工程指示 / 要求簡箋(E.I.)

工程指示編號：EI / 1515 / 20 修改版次：

工程名稱：亞皆老街中電

工程項目：Showflat 後加工程

CL-01

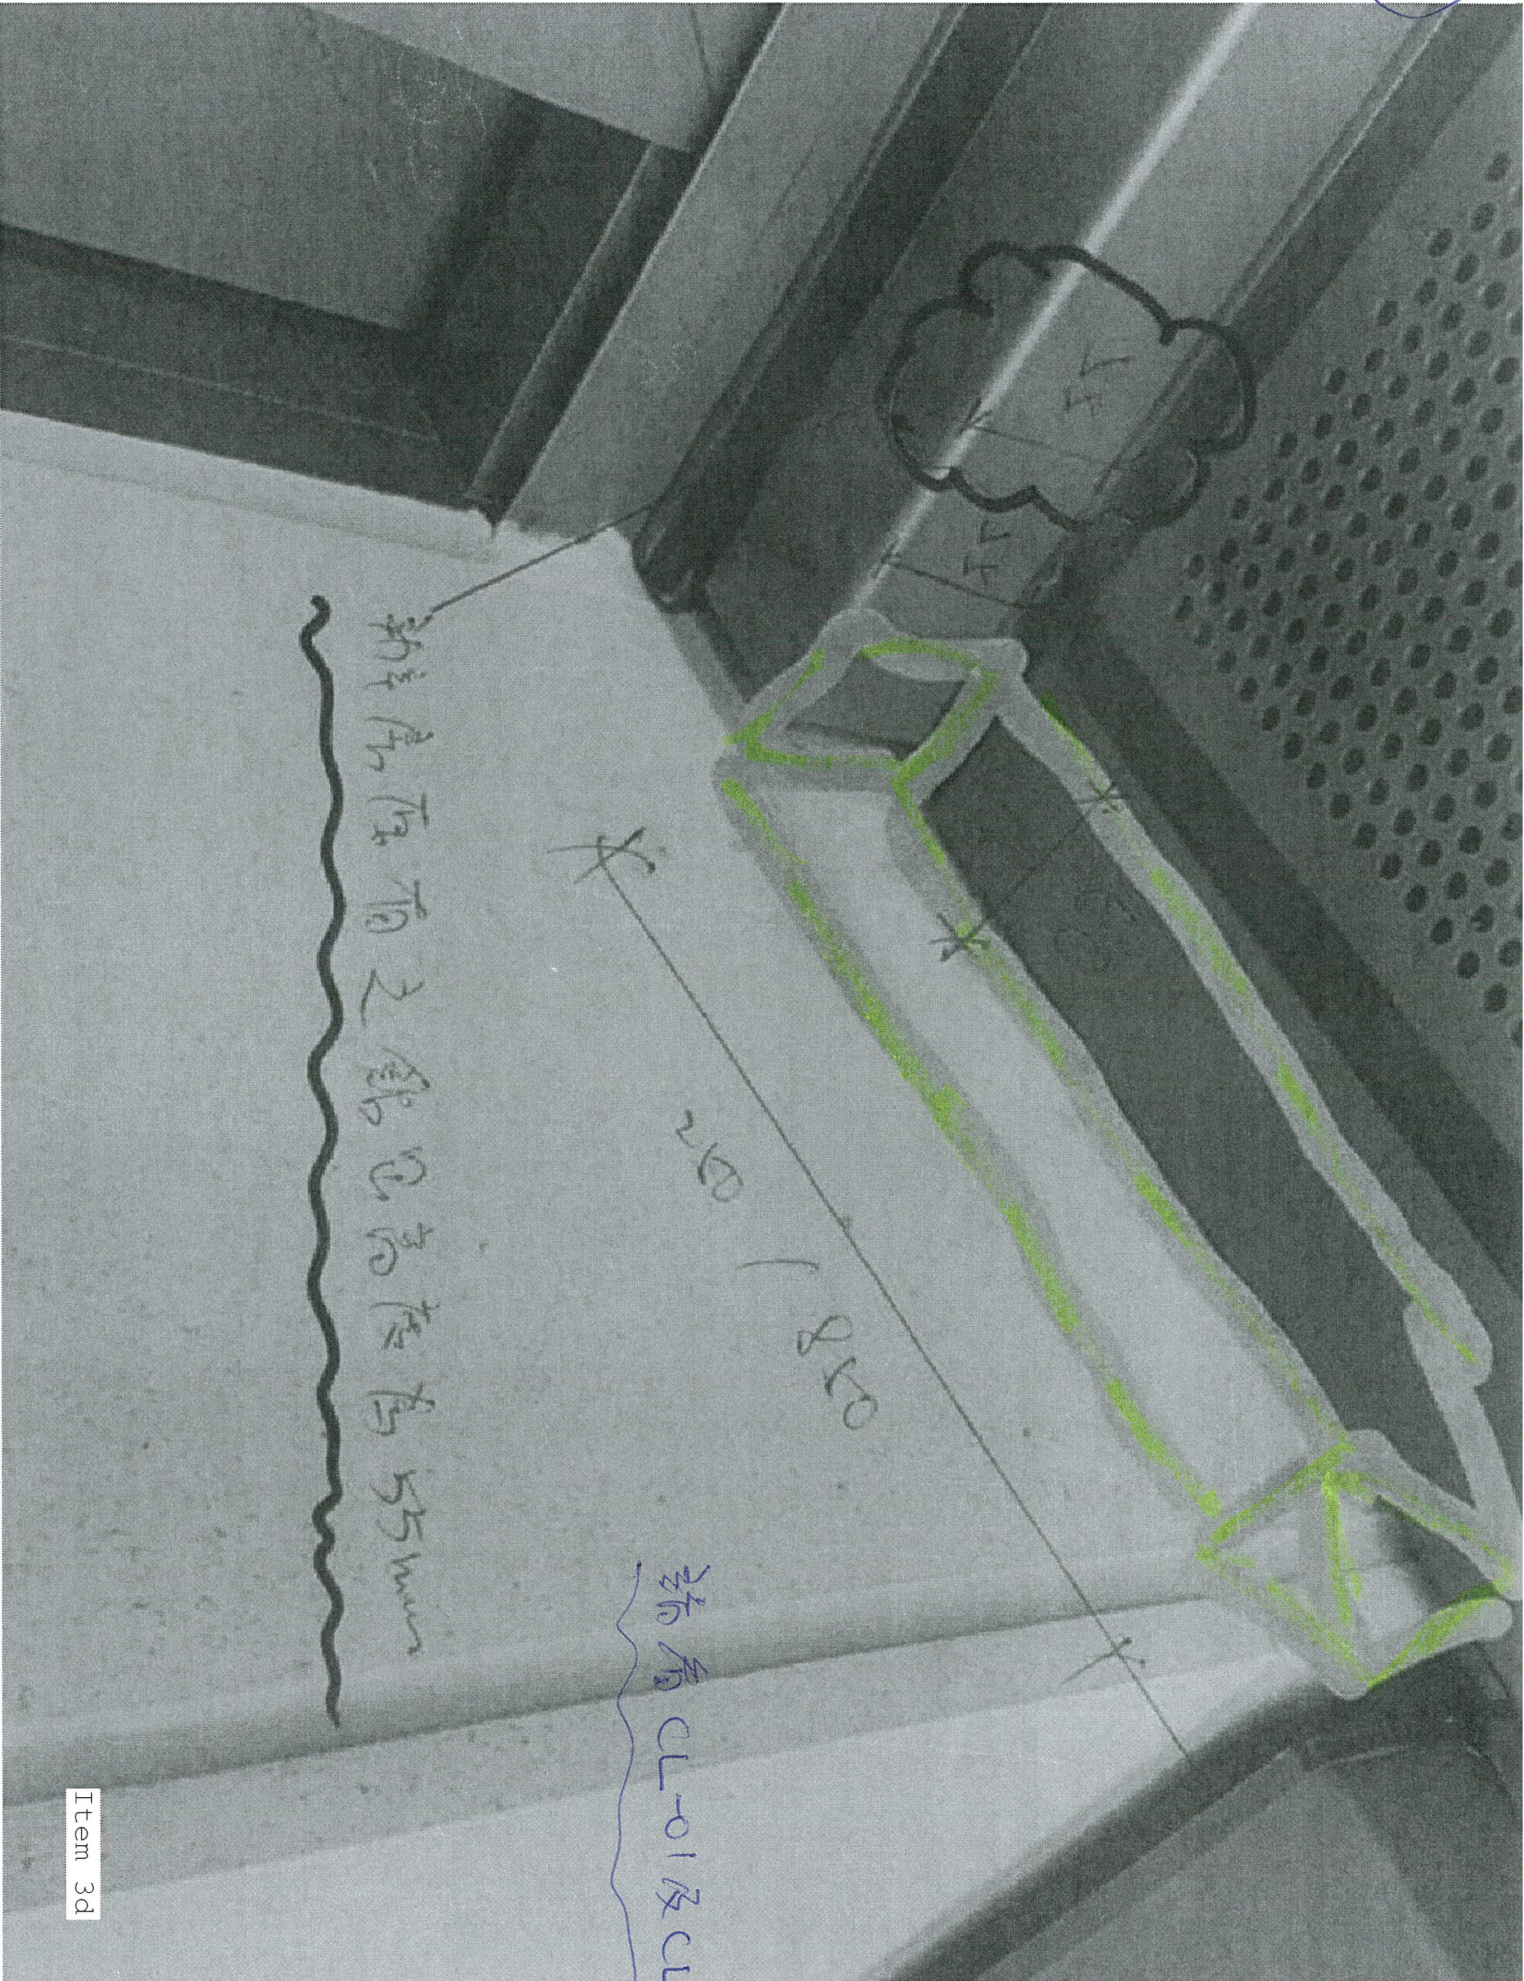
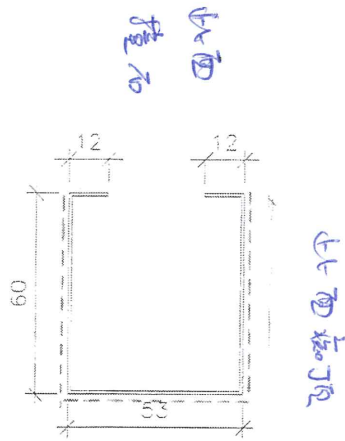
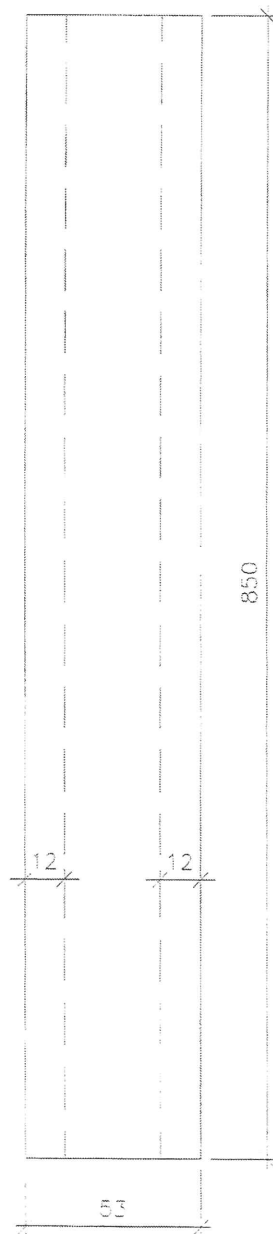
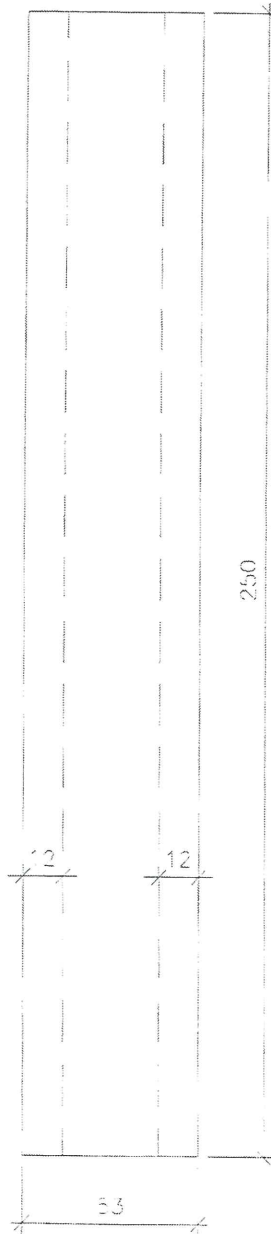
3. Flat C 露台 欄河及天花用鋁匣

辦字房原有之鋁包高度為 55mm

請看 CL-01 及 CL-02

1mm 鋁板

1mm 鋁板

Sk-01

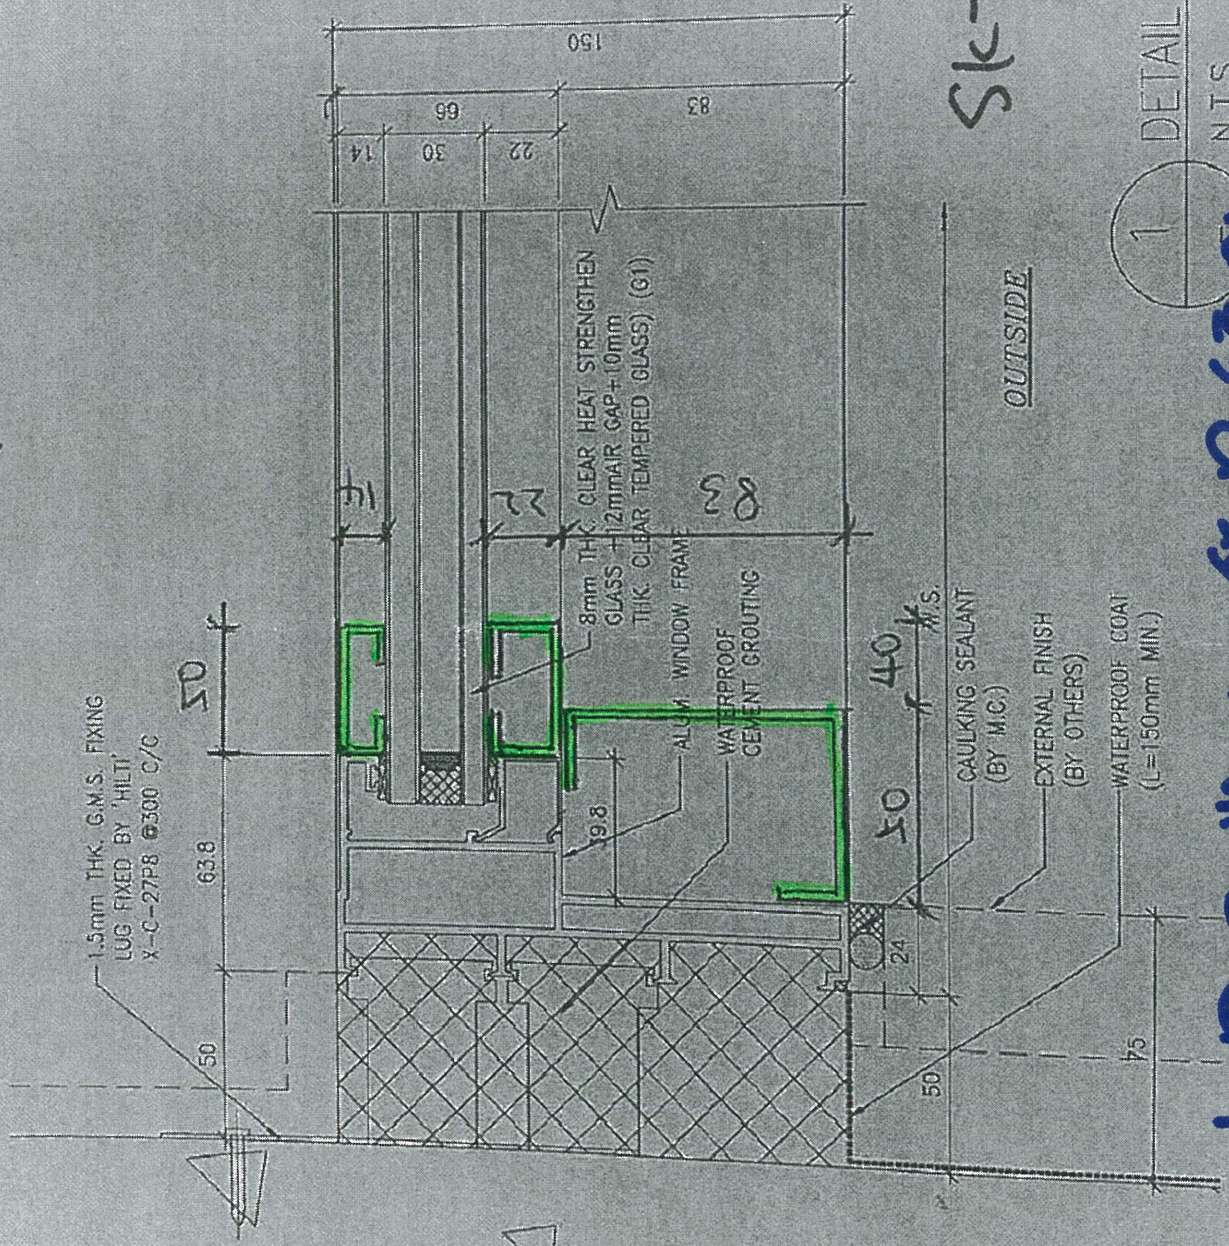
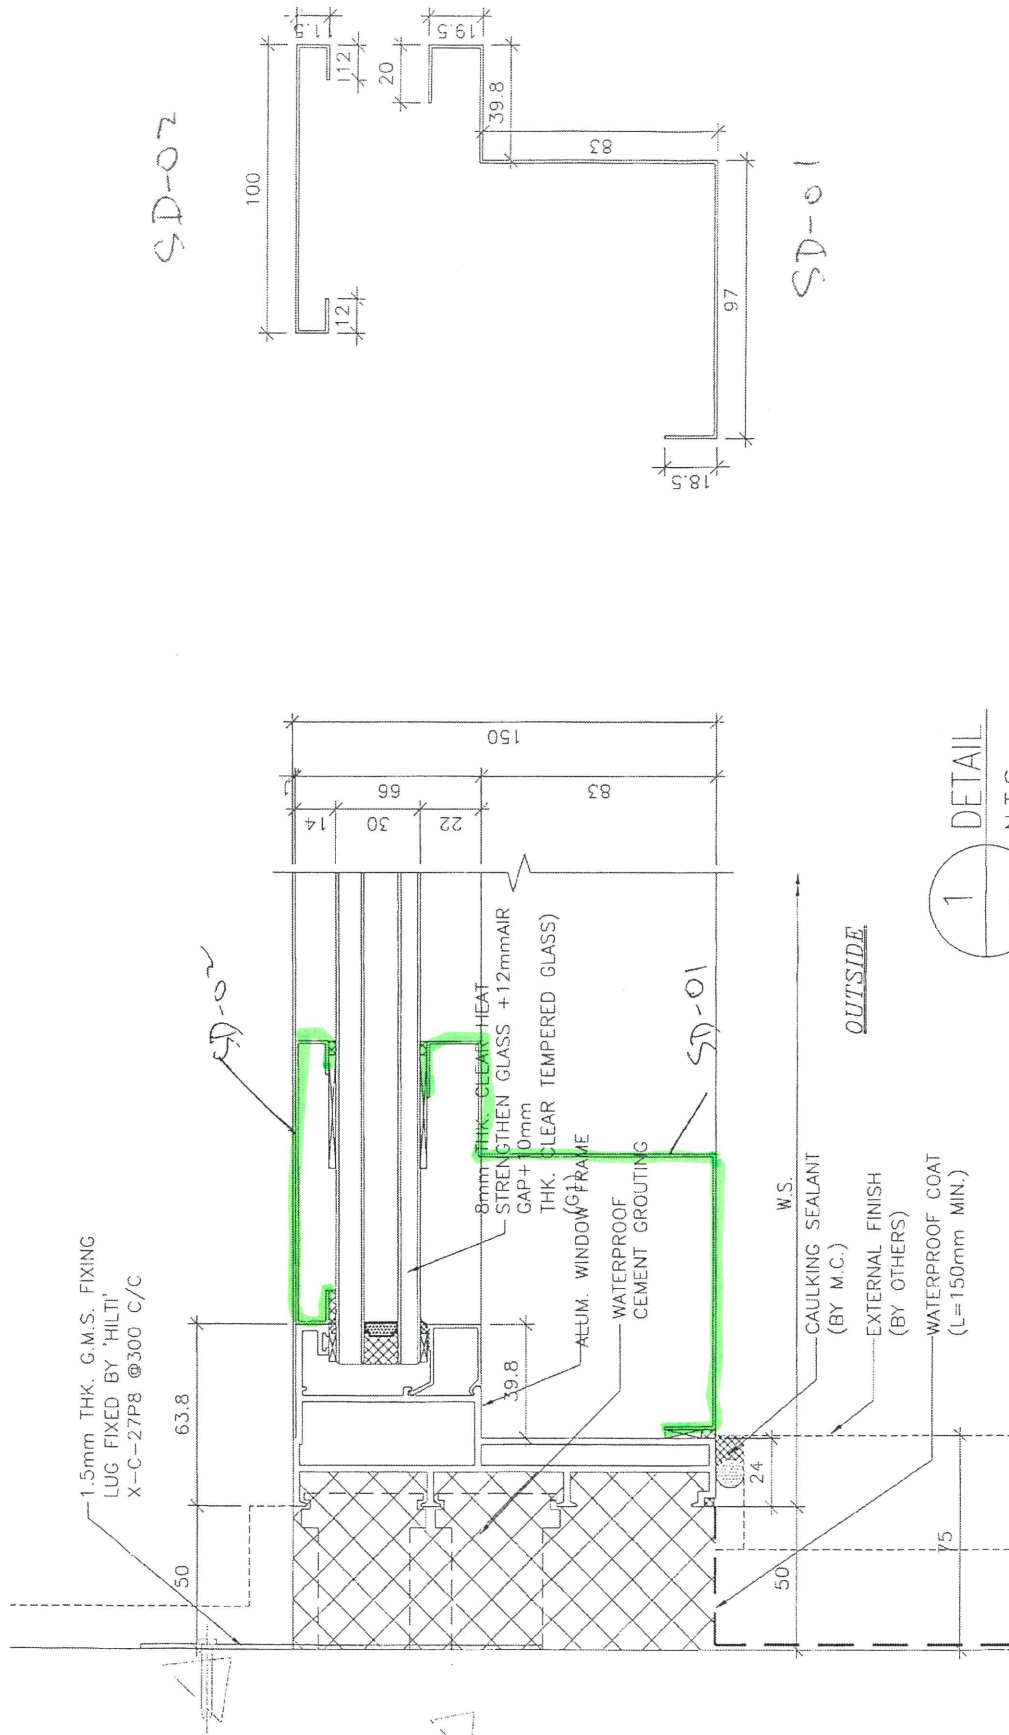
4. 關於項目 2, 我司按 SI 指示在 Flat A 大露台左右兩邊企身安裝鋁匣後, 由於則師要求更改趟門設計以確保有足夠的 OPENABLE AREA, 現須拆下已裝之鋁匣, 然後再重新安裝新的鋁匣。此項修改未有 SI, 但業主已電郵確定, 現附上 2 月 10 日由信和 JIMMY 發出的電郵。

With reference to the attached SI issued by you regarding the additional works at showflat, please note that additional aluminium cappings for T1 Flat A sliding door were installed on 24 Dec 2019 according to the attached drawing SK-01 from SI. However, refer to the below e-mail, revised details of sliding door approved by architect on 8 Jan 2020 do not match the showflat. Therefore, aluminium capping for sliding door at showflat T1 Flat A balcony should be modified according to the attached drawing SK-02 in order to match the approved details. Please note that the aluminium capping would be dismantled and re-installed and please kindly confirm the aforesaid additional works.

上圖已裝的鋁窗須拆下
(在身在右兩邊共6件)

No adverse comment. Pls proceed.

新鋁包 (在身在右兩邊合共 4 件) Sk-02
